Seat Badge Tape Improvement

Situation

Seat badge tape may wear prematurely.

Tool: 1038996

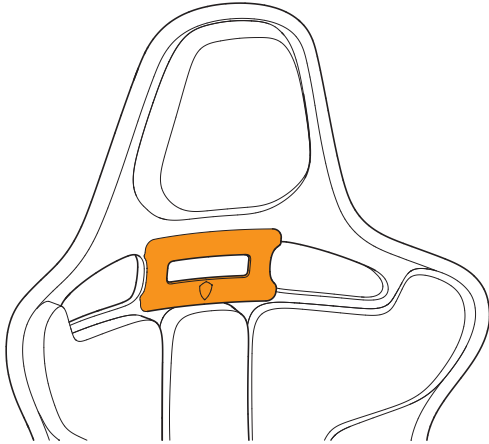
6. Align the template with the seat and attach it with masking tape.
